Kensington Heights Site Plan No. 820140040

Staff Report Date: 04/17/14

Description

Figure 4: Areas of Community Concerns

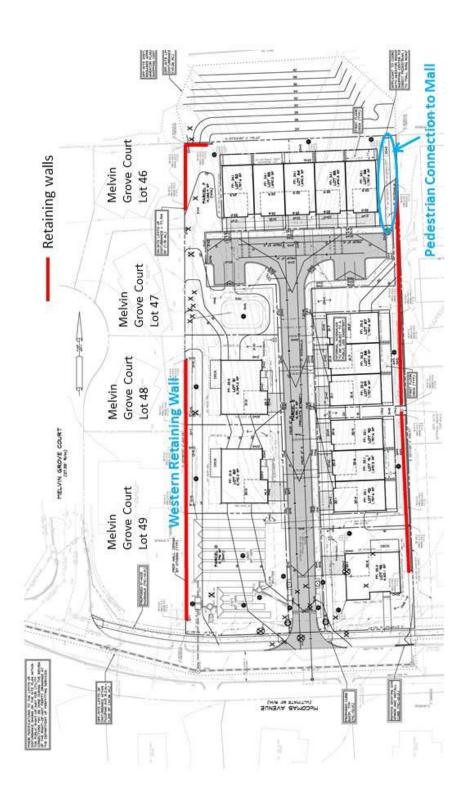
Mr. Agliata fears that whenever Westfield Wheaton Mall redevelops, it will be required to complete the pedestrian connection on the Mall property (Figure 4). He disagrees with having a pedestrian connection to the Mall in this location because of the area's steep topography and the safety and subsequent liability concerns with creating this connection. He argues that the Sector Plan did not envision a pedestrian path in this location. Westfield also sent a letter in opposition to this recommendation which is attached as Attachment F at the end of this report. The letter further points out that the fifth general note on the Schematic Development Plan for the project states:

This note was added in response to the People's Counsel and local residents' concern that a pedestrian connection to Westfield Wheaton Mall site would bring crime to the residential area south of the Mall.

The existing informal path on the Subject Site shows that there is a demand for a pedestrian connection to the Westfield Wheaton Mall property in this location. Although the Sector Plan does not specifically recommend a pedestrian connection on the Subject Site, it discusses the green buffer between the Mall's Ring Road and the adjoining residential community to the south (which includes the Subject Site). It states on page 53, "Also consider additional shared use path connections through the buffer to the neighboring community." Despite the note in the Schematic Development Plan, quoted above, the Planning Board included the recommendation for this connection in its approval of the Preliminary Plan for the Subject Site. Therefore, Staff recommends that the Applicant provide the proposed pedestrian connection as shown on the approved Preliminary Plan. In the future, the Planning Board can decide whether or not Westfield Wheaton Mall should provide this connection.

In response, the Applicant reduced the height of the proposed retaining wall to be no more than four feet at its highest point (Figure 4). In compliance with County code requirements, parts of the wall will be topped with a fence/railing no more than approximately three feet tall. At its highest, the wall, including the fence/railing will be approximately seven feet. As a comparison, the average residential privacy fence is up to six feet. To make sure that the proposed retaining wall/fence does not become too tall and looming over the adjacent properties, Staff recommends that the fence/railing be transparent (e.g. metal railing). Staff finds that the height of the proposed retaining wall with a transparent fence/railing is reasonable. The retaining wall is needed due to the topography of the site and to contain and manage all stormwater runoff on-site, which will rectify the existing condition of stormwater runoff flowing to the neighboring properties.

DPS-ROW CONDITIONS OF APPROVAL Attachment D

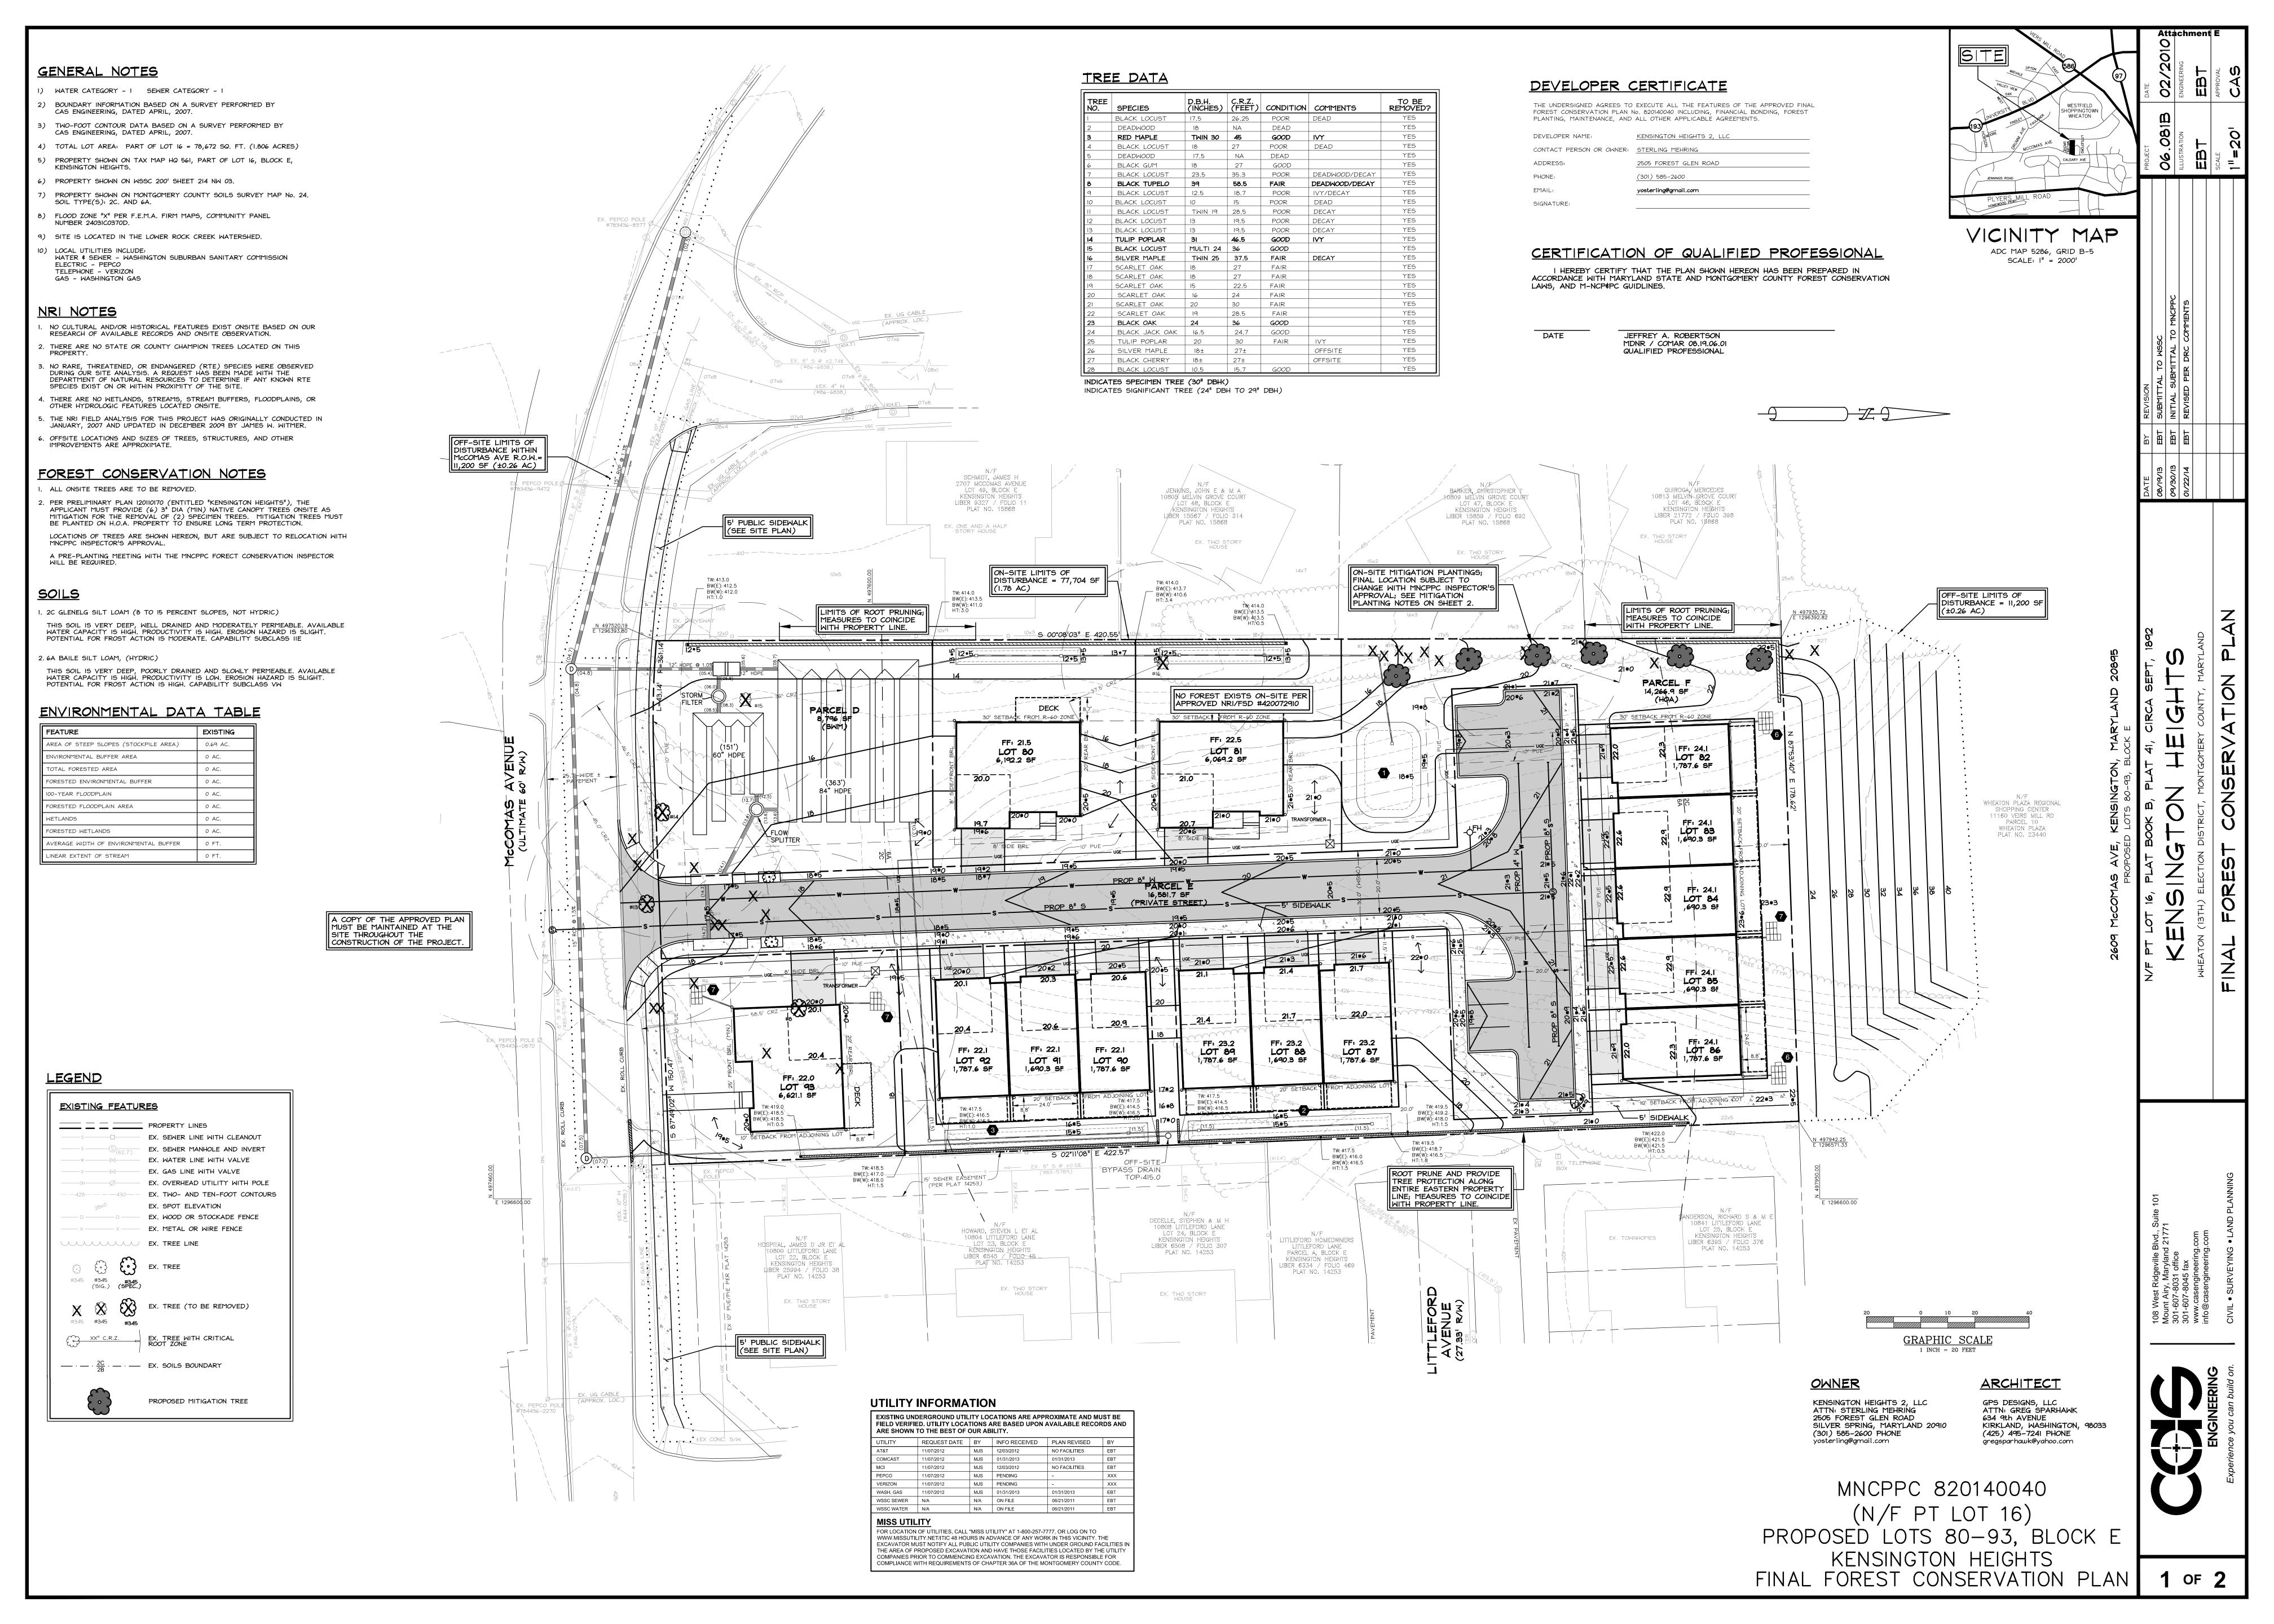
We approve site plan file "07-SITE-820140040-003.pdf V6" subject to the followings to be conditions of the certified site plan to be done prior to ROW permit stage:

- o Private open space covenant;
- Slope/drainage easement;
- o Investigate and re-route the proposed storm drain out of pavement;
- o Private streets to be built to tertiary roadway structural standards;
- o Handicap ramps on all plans should match the site plan file above.
